**BLOCK 18 SECTION 11 – MITCHELL**  
**Application Number: 201733198-S165C**

**Description: PROPOSAL FOR CHILDCARE CENTRE - construction of a new 3 storey childcare centre, new driveways, car park and dropoff area, landscaping and associated site works.**

**Application No:** 167848 **Suburb:** Mitchell

SK 200

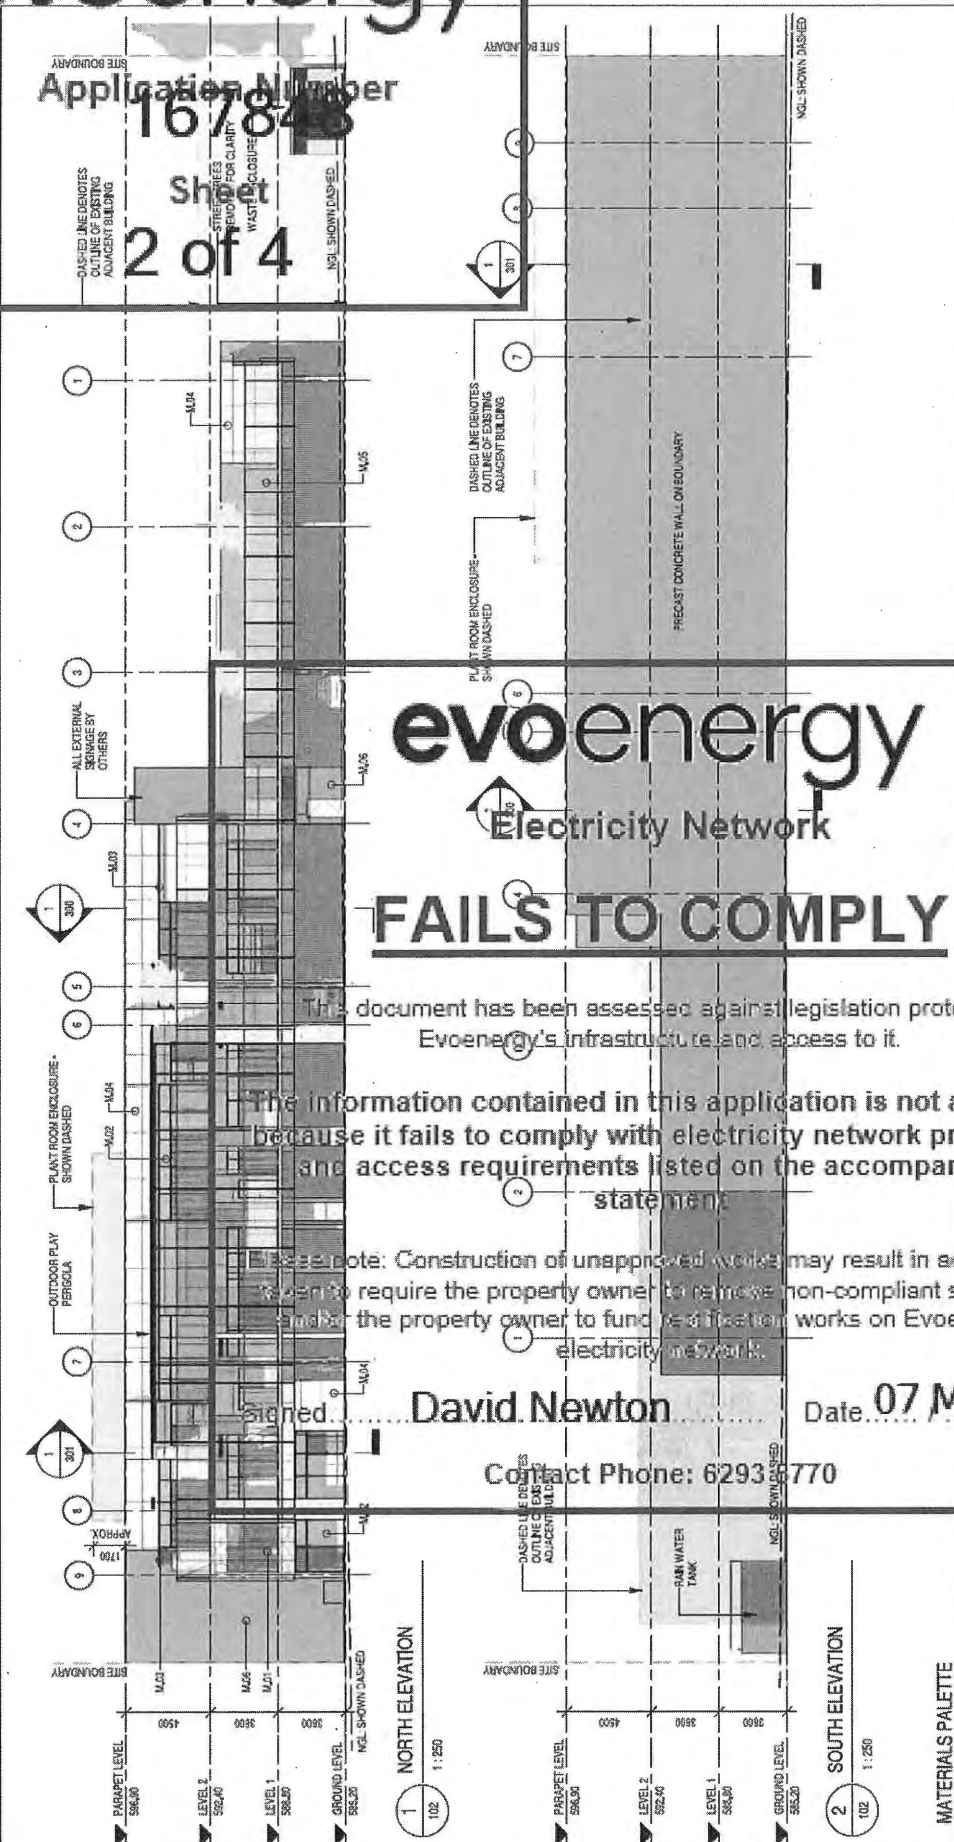
Development is to comply with minimum clearances to overhead conductors and poles. Ref Evoenergy Drawing 3811-004

Survey location of closest conductor at pole 27066, show minimum 2.7m clearance from proposed building to conductor on elevations. Scaffolding required during construction will not comply with clearances to bare overhead low voltage conductors.

## FAILS TO COMPLY

The information contained in this application is not accepted because it fails to comply with electricity network protection and access requirements listed on the accompanying statement.

SK 201

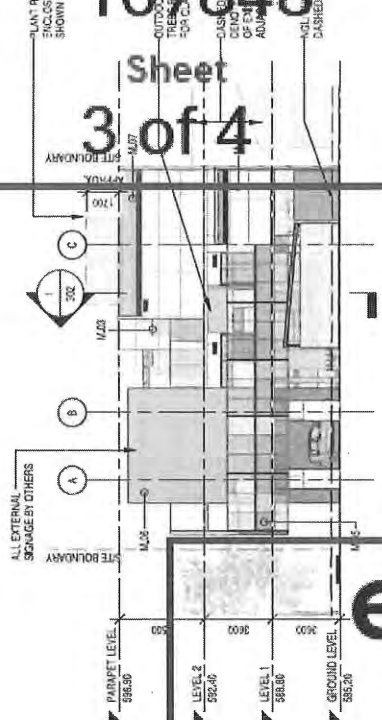
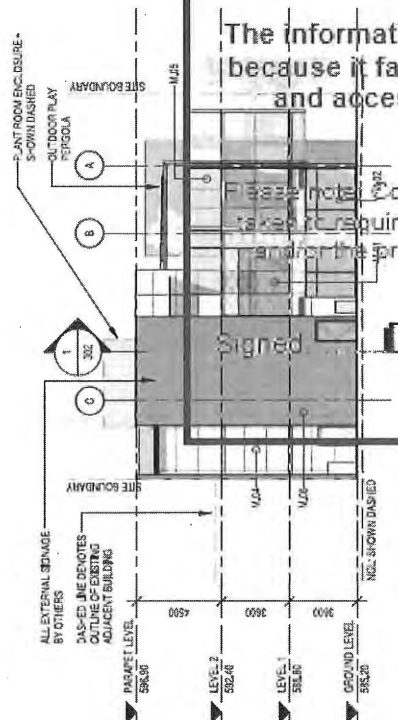
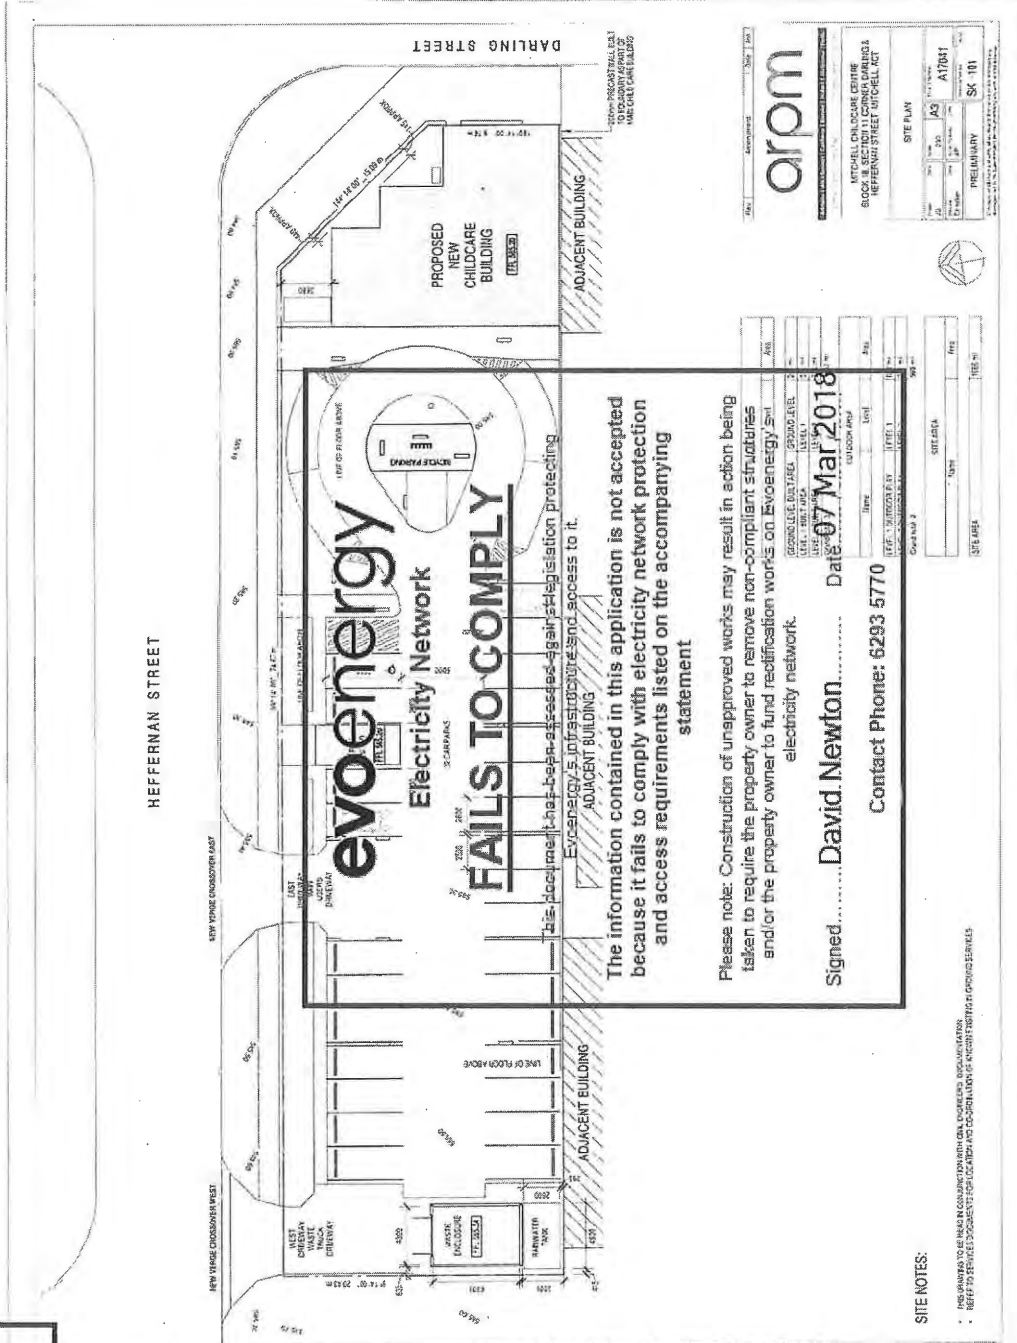
## FAILS TO COMPLY

The information contained in this application is not accepted because it fails to comply with electricity network protection and access requirements listed on the accompanying statement
